## ***Interactive comment on “Evaluating the hydrological consistency of satellite based water cycle components” by O. López et al.***

**O. López et al.**

Received and published: 26 July 2016

Fig. 1. Supplementary Figure 1

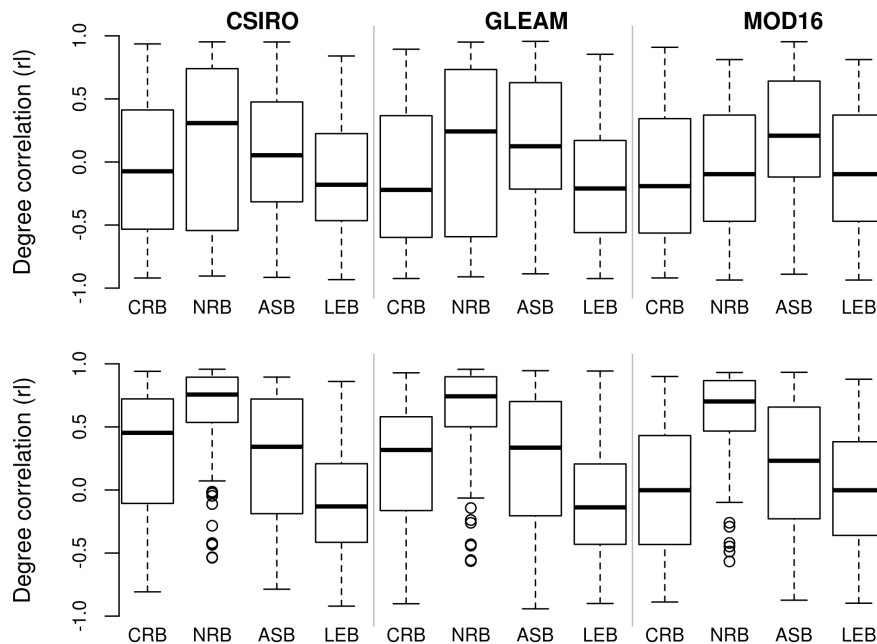
Comment 13. It is also unfair to put 'the blame' on ET, because P is a much more likely candidate for this uncertainty. You need to describe better why ET is so important in this analyses. My guess is that you want to say that, despite being the second-largest component of the water budget, ET is most uncertain. Can you derive uncertainties of all estimates? This study would be much stronger if it could quantify what absolute values of inconsistencies we are talking about.

Author response. As mentioned earlier, the focus on evaporation in this study was based on a need for an alternative way to evaluate satellite evaporation products (since in-situ observations are not the best way forward). Therefore, only a single precipitation product was explored: albeit one that has been well studied and used in global analysis. But this is also true for the water storage variations: although there are a number of water storage products based on GRACE satellite data (Bruinsma et al., 2010; Liu et al., 2010; Rowlands et al. 2005), the choice of a particular product (CSR) was based on its widespread use in a number of previous studies. Having said this, other precipitation products can certainly be considered and can be explored in a revised version (see earlier comment and preliminary results with PERSIANN).

Figure S1. Top: average degree correlation statistics per study region and evaporation product. Bottom: GRACE data were shifted by two months to match the phase with P-E anomalies. The boxplots show the first, second (median) and third quartiles. Outliers, defined as data outside the 1.5 inter-quartile range (IQR) whiskers below or above the first and third quartiles are shown as circles. This figure represents a summary of the analysis using the PERSIANN product as precipitation. **The results are very similar to those in Figure 8.**
